2NSW-108 (sheet 2 of 2)
Upper Containment Ventilation
Unit 4 Supply Line

NPS DESIGNS INC. NEW YORK, N.Y.
LIVSEY & COMPANY, INC. INDIANA & MICHIGAN ELECTRIC CO. DONALD C. COOK NUCLEAR PLANT

CONTAIN. VICINITY
DWG. NO. 2-NSW-108
SH. 20F2

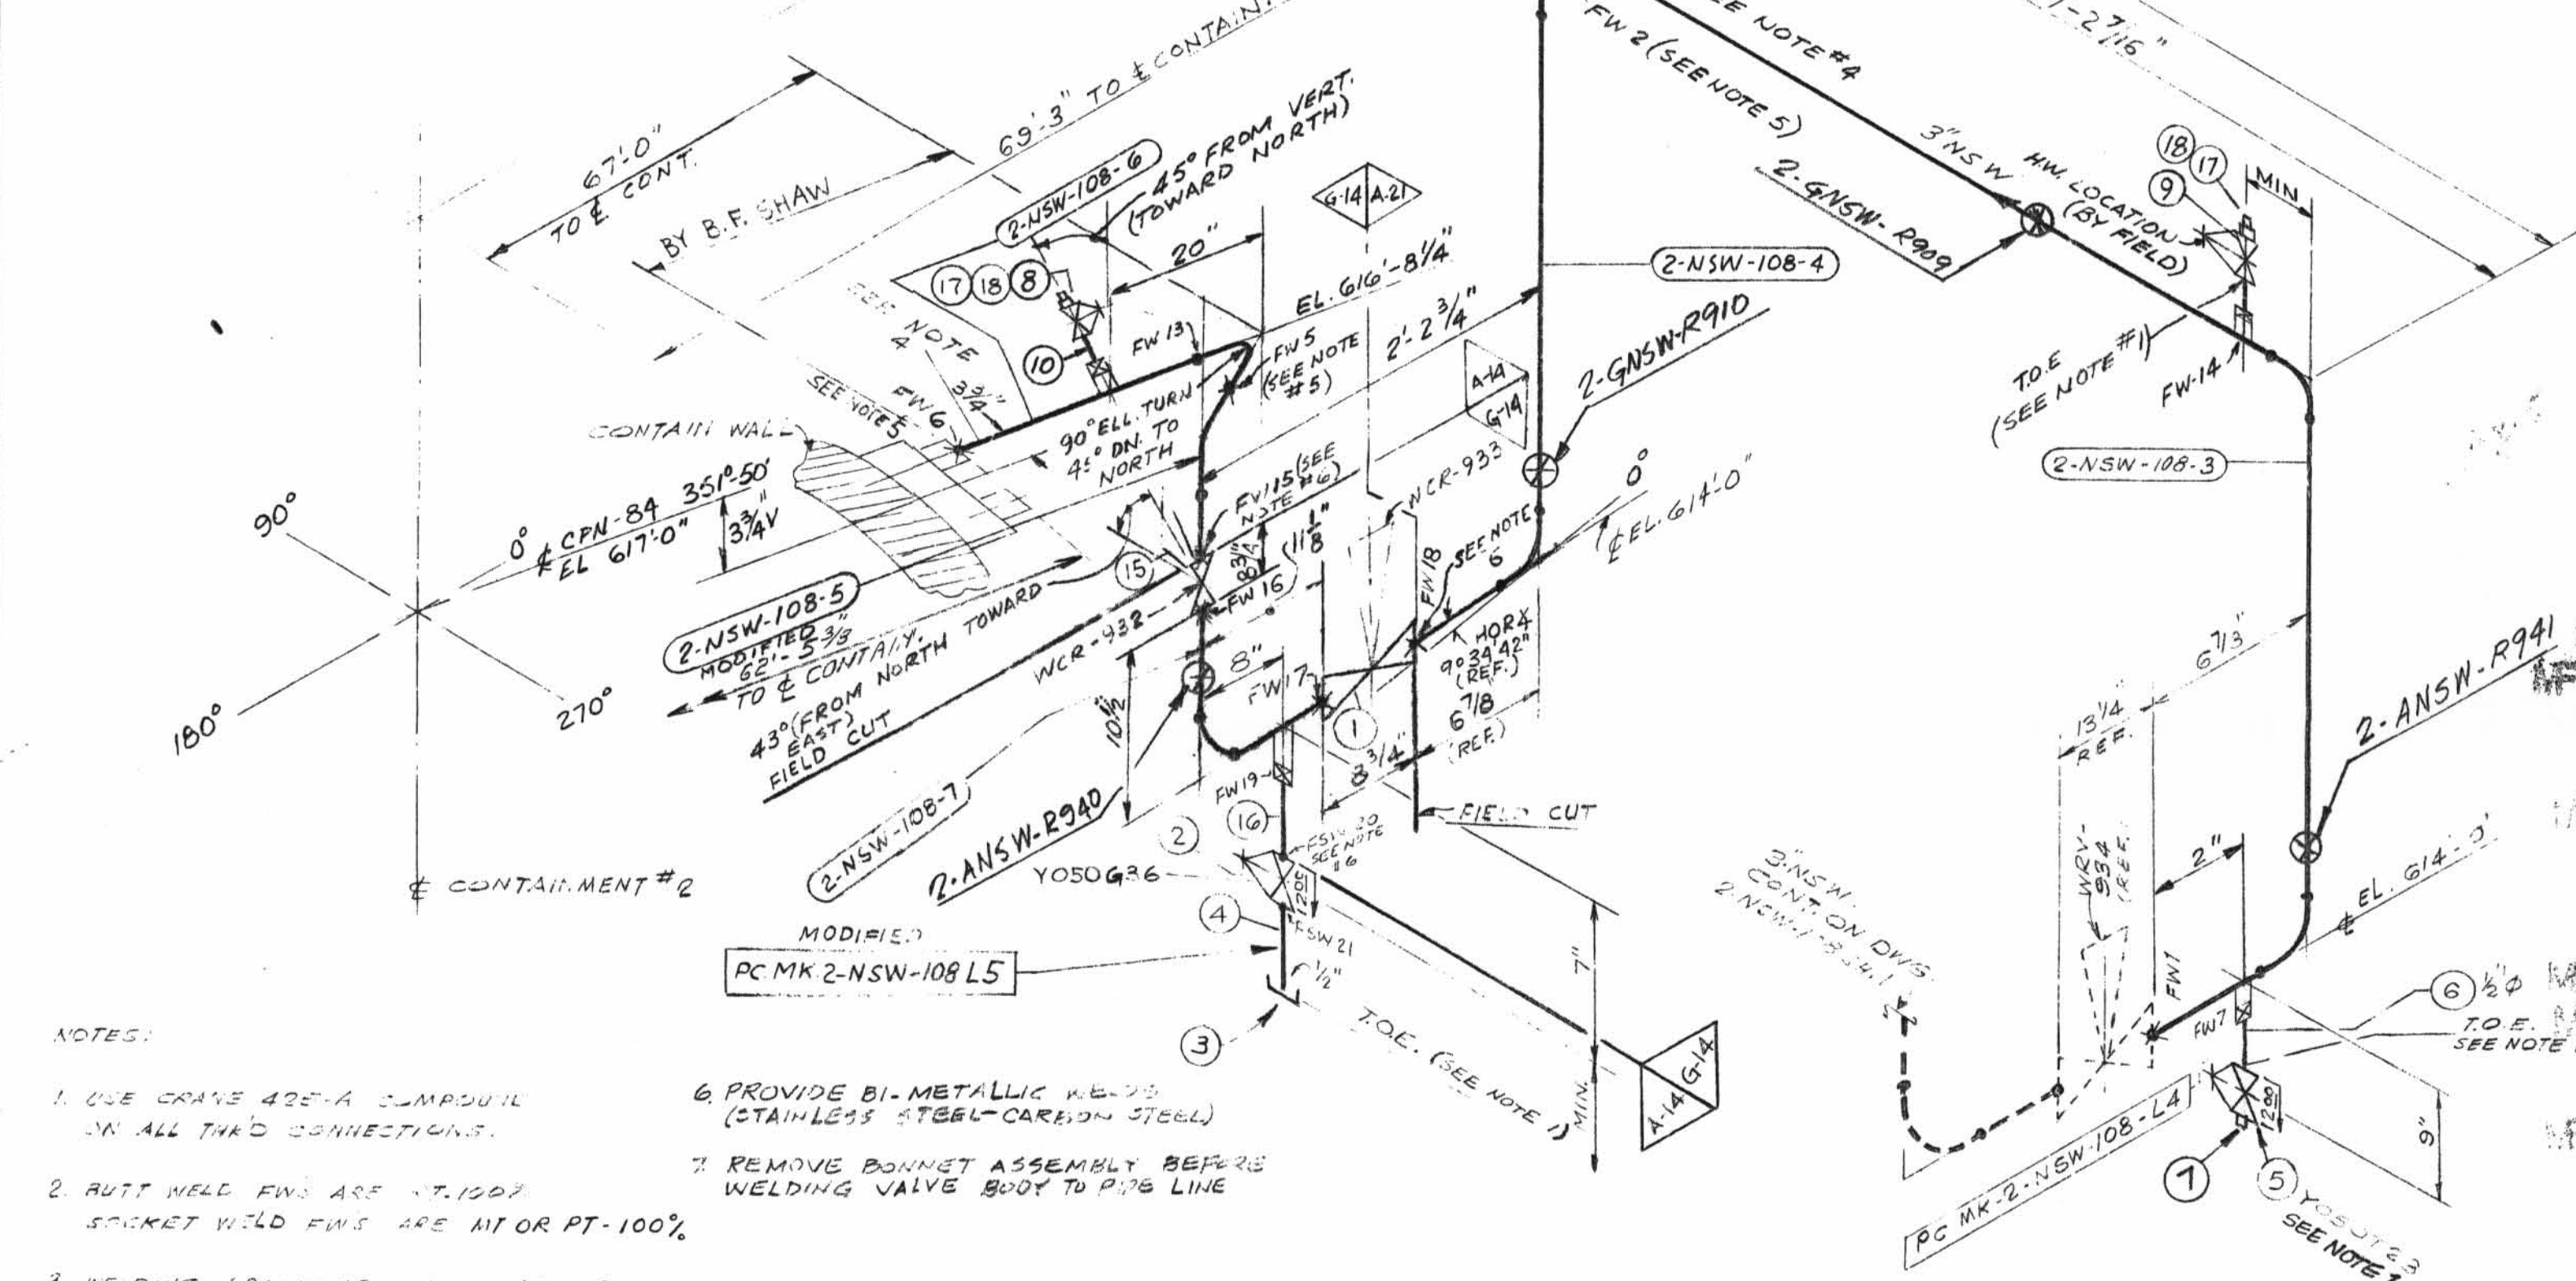
| REVISION RECORD | | | | |
|-----------------|---------|----------|--|------------------------|
| 1 | 7-11-75 | DR | REV'D BY AEP DESIGN: PER RFC-DC-12-671: REV'D; ITEM #2 Y-050G36 WAS CY-050G36. ADDED; 3" CHECK VALVE - CISCE03A, (2) 1" VENTS - VALVE NO Y-100T23. | ACTION REQ'D. |
| 2 | 5-27-76 | BH. H.G. | REVISED FABRICATION RESPONSIBILITY OF SPOOL PC. 2-NSW-108-6. | |
| 3 | | | 6" G 3/4" HAS 6" 1/8" 1/2" ADDED TO RETAIN ITEM 8. | |
| 4 | 2-17-82 | GP LB | AS PER RFC-12-1430 DELETED VALVE TAG NO. CISCE03A, ADDED VALVE TAG NO. CISCE03A & ITEMS 11 THRU 14 AND REVISED RELATED PIPING. | FIELD ACTION REQ'D |
| 5 | 9/1/81 | KA | PER RFC DC-12-2549 REPLACED 3" CHECK VA. & WCR-933 WITH DIAPH. VA.'S WCR-932 & 293. ADDED: PIPE SPEC. G-14, NOTES G & T, FIELD WELD BOX, FIELD WELDS FW 15 TO 19, FSW 20 & 21, 2-NSW-108-7, ITEMS N5 & 16 TO B.M. DELETED ITEM N5 7, 11, 12, 13 & 14 FROM B.M. MODIFIED PEAK 2-NSW-108-5 & 2-NSW-108-L7, REVISED ITEM N5'S 1 & 9 | FIELD ACTION REQ'D. |
| 6 | 9/1/81 | KA | PER RFC DC-12-2549 ROTATED VALVE ACTUATOR. ADDED DIM 1138 & REF NOTE | FIELD ACTION REQ'D. |
| 7 | 1/2/81 | J.L. | PER RFC DC-12-2549 DIM. 7-2716" WAS 7-23716" AND ADDED DIM'S. | NO FIELD ACTION REQ'D. |
| 8 | 6/14/82 | DR. | PER RFC-DC-12-2549: REVISED LOC. OF WCR-932 AND RELATED PIPING AS PER FIELD VERIFICATION & ADDED RED. INSERT & PLUG TO ITEM 8 & 9. | FIELD ACTION REQ'D. |
| 9 | 7/12/80 | EPB | TO REFLECT AS-FOUND CONDITIONS FOR RFC-DC-12-3010 PER FWR#750 REV. 1, ADDED: 1" X 3/4" RED. INSERT, 3/4" & 1/2" PLUG. REVISED; B/M TO SUIT. ADDED; SUPPORT MARK NOS. & SUPERSEDES HGR. 190. NO. 2-GNSW-108 SH. NO. 2. | NO FIELD ACTION REQ'D. |
